MEMORANDUM

**Subject: Review of Contaminant Conditions
CSXT Bramlette Road Former Manufactured Gas Plant (MGP)
Greenville, South Carolina
Project No.: 019-12**

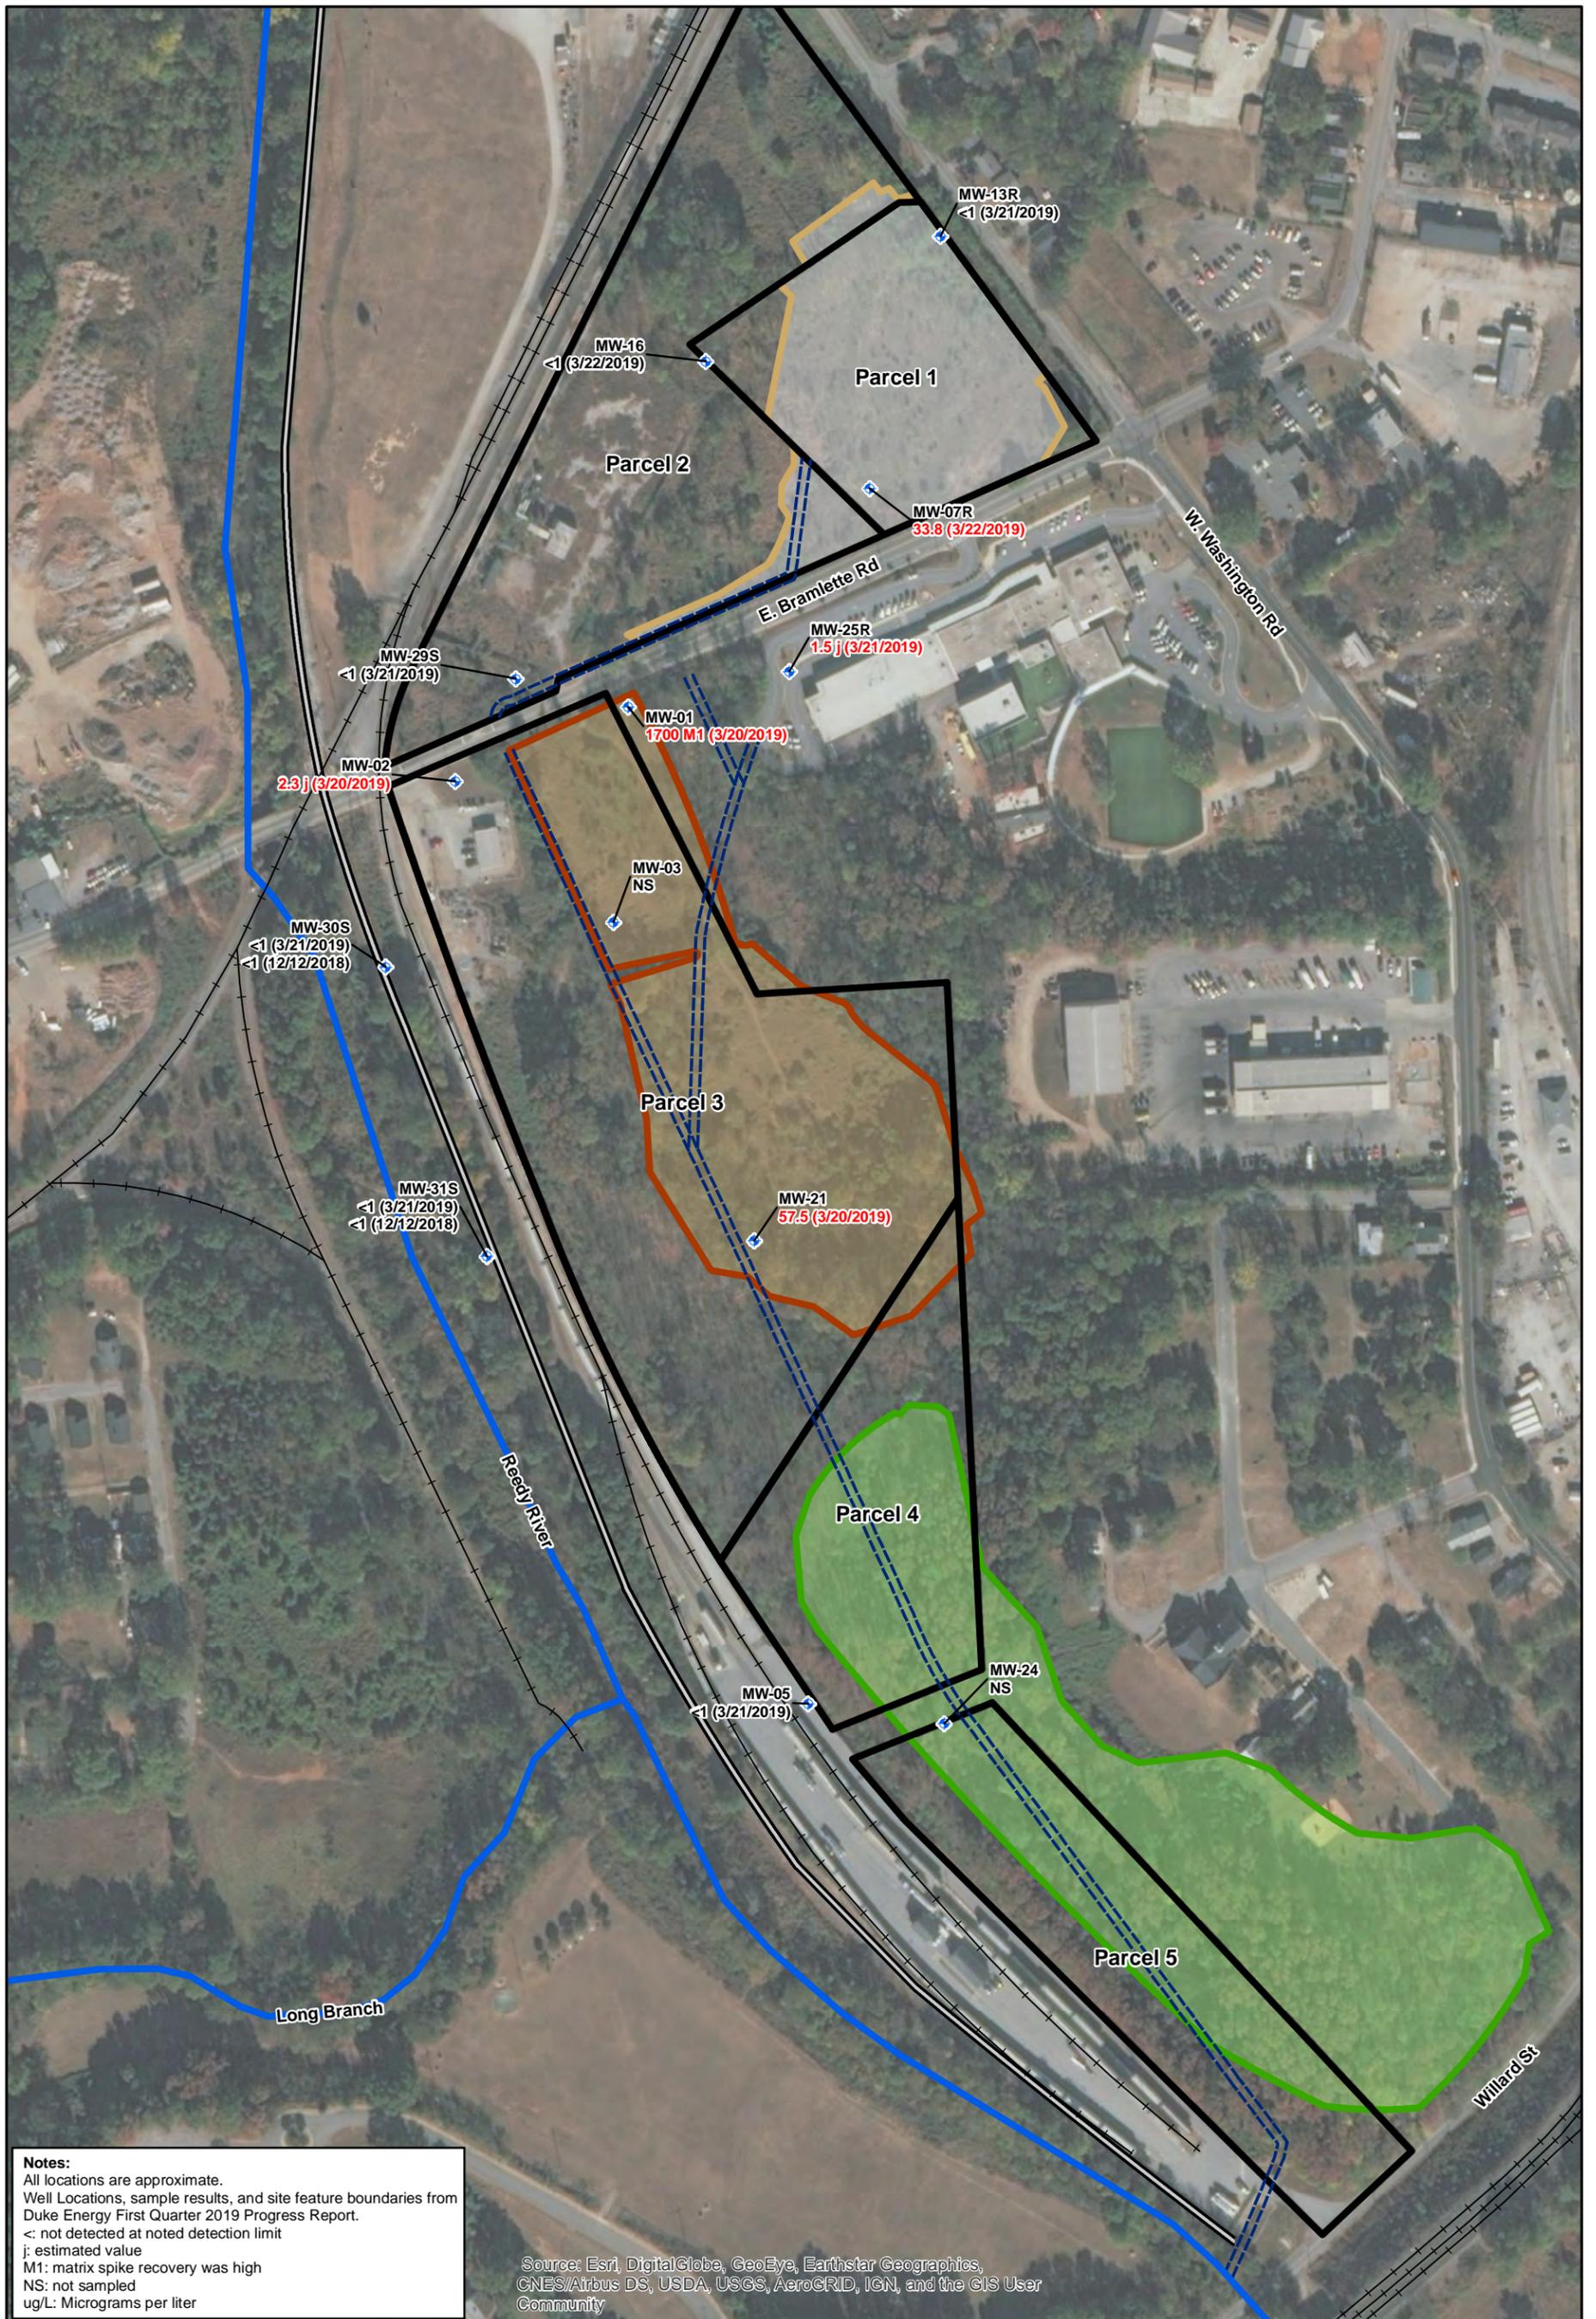
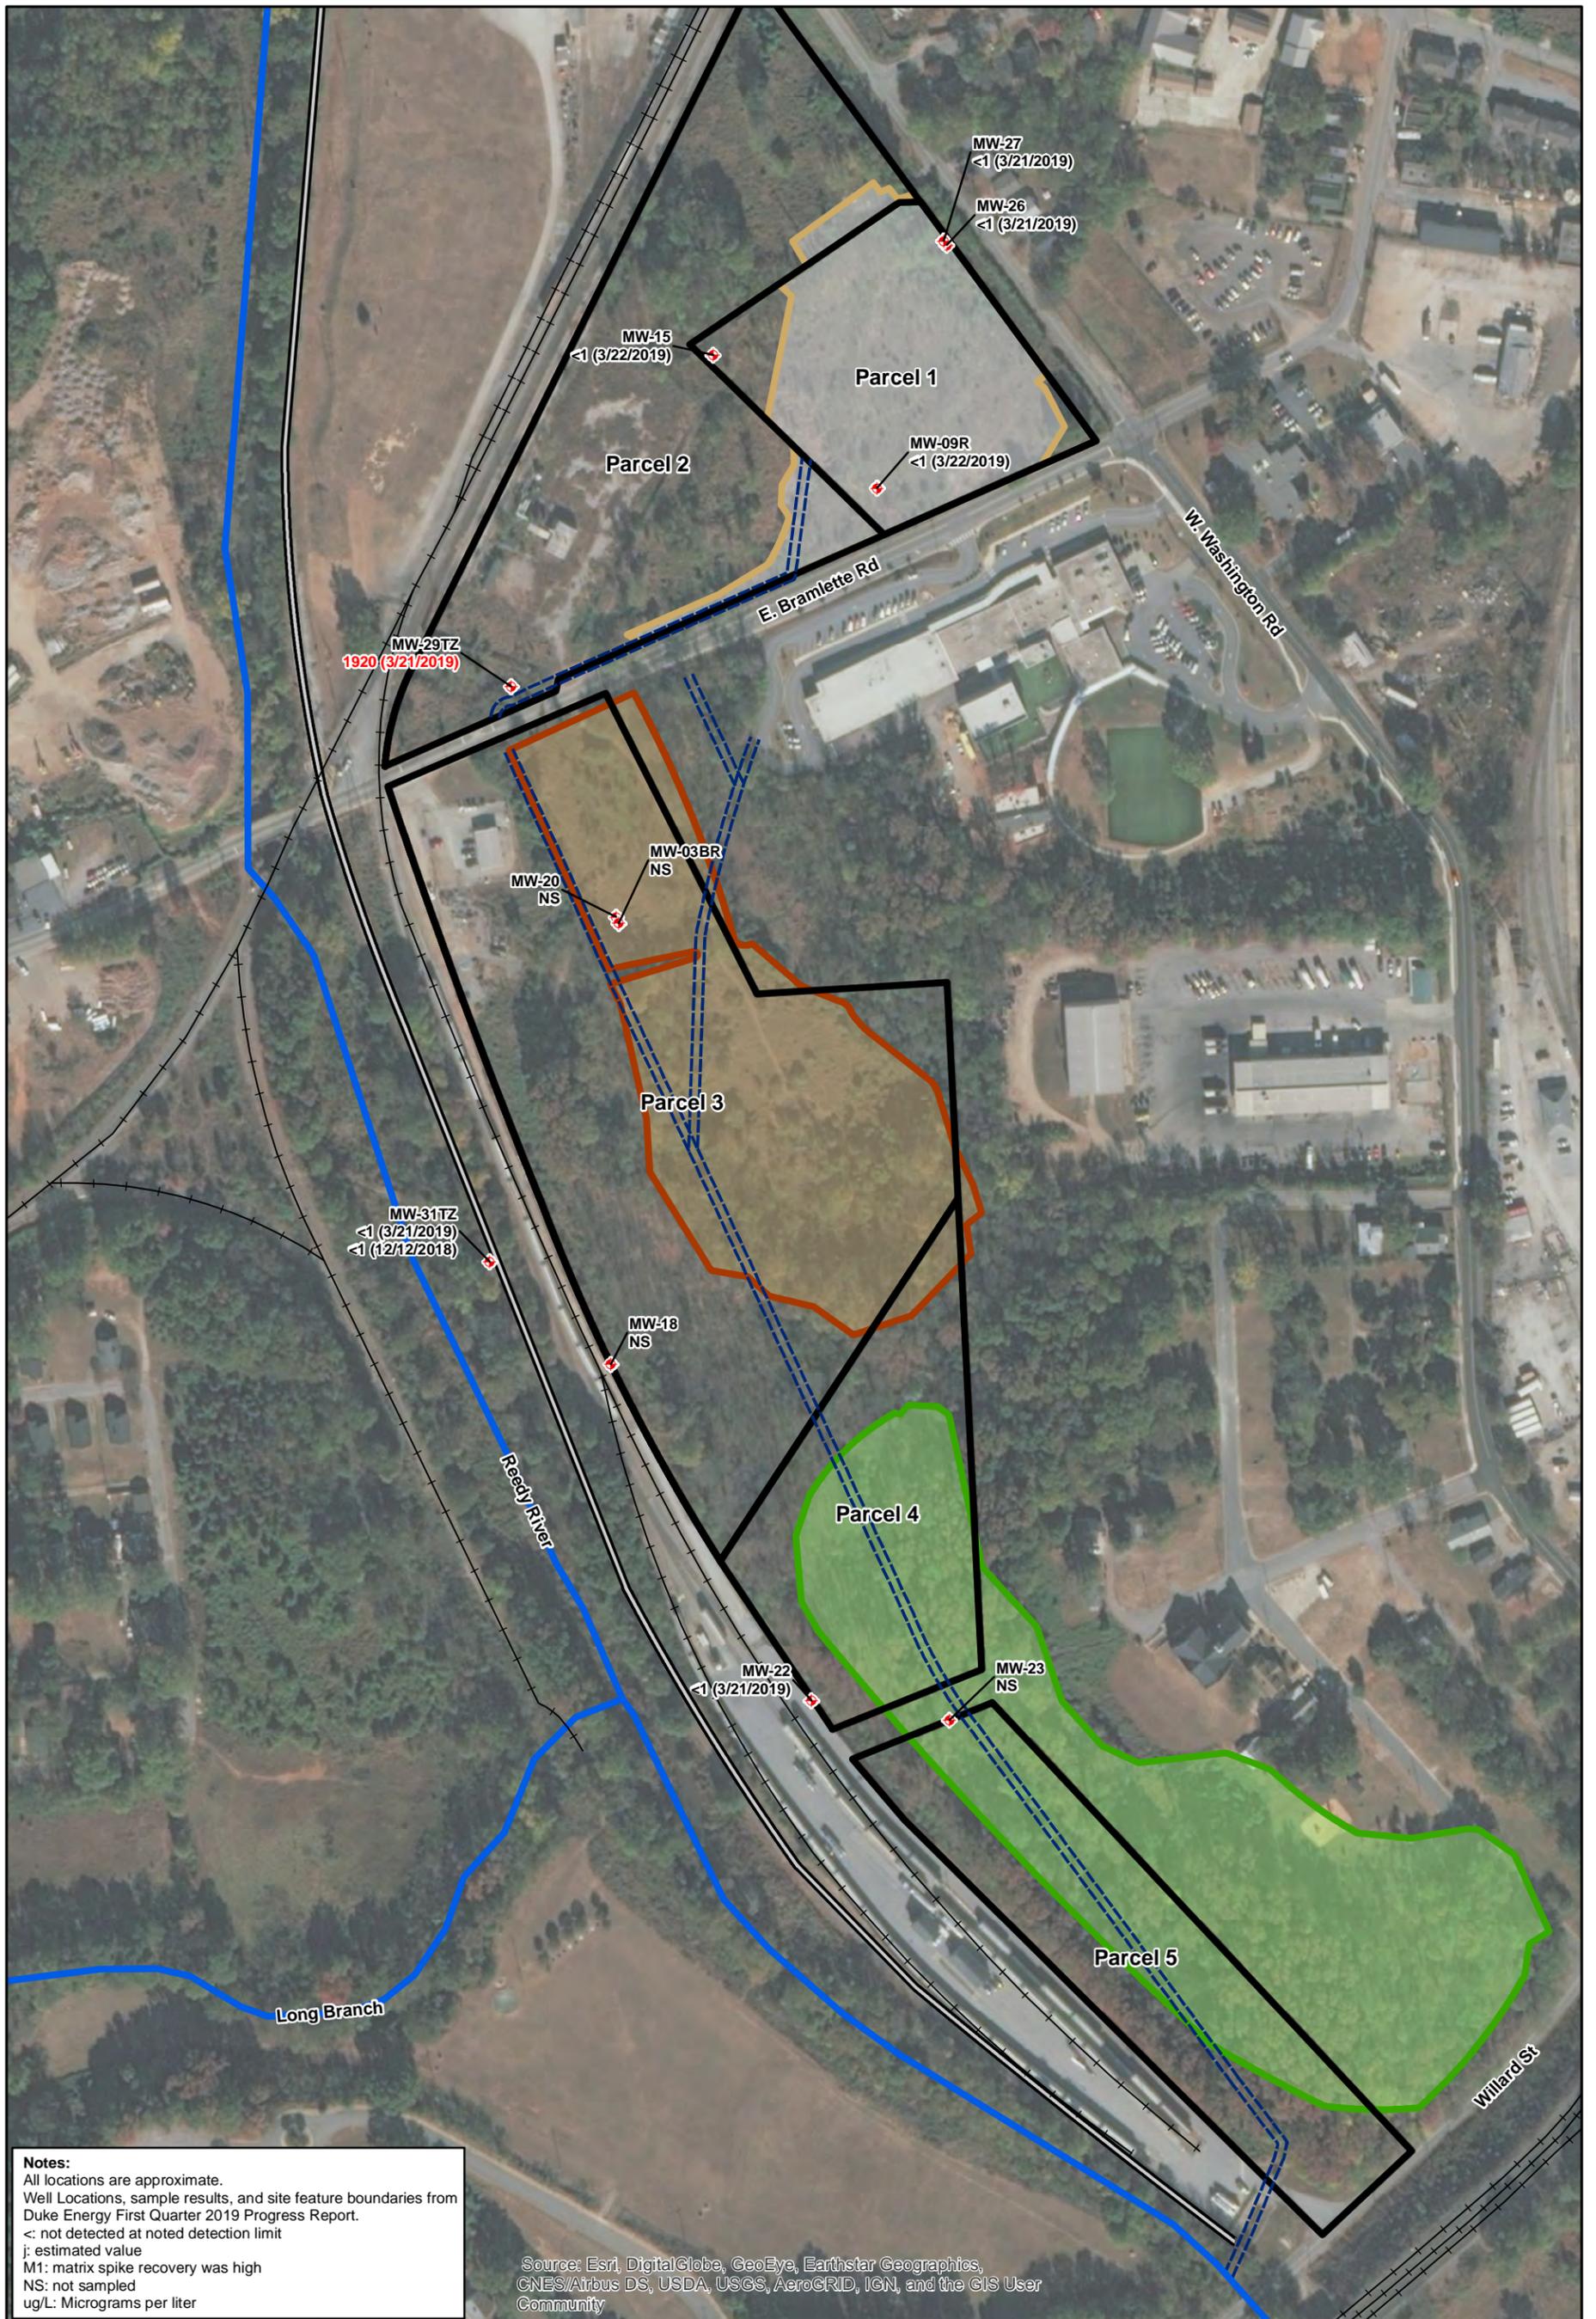
Neither the maximum depth nor the down-gradient extent of benzene and naphthalene (as indicator compounds for VOC and SVOC contamination) contamination in groundwater have been delineated (**Figures 4 through 7**). As mentioned above, benzene and naphthalene were detected at concentrations of 1,920 ug/L and 4,060 ug/L, respectively, in a groundwater sample taken from MW-29TZ. MW-29TZ is located approximately 500 feet down-gradient of the former MGP. No monitoring wells have been installed beyond MW-29TZ north of East Bramlette Road in the down-gradient direction (**Figure 1**).
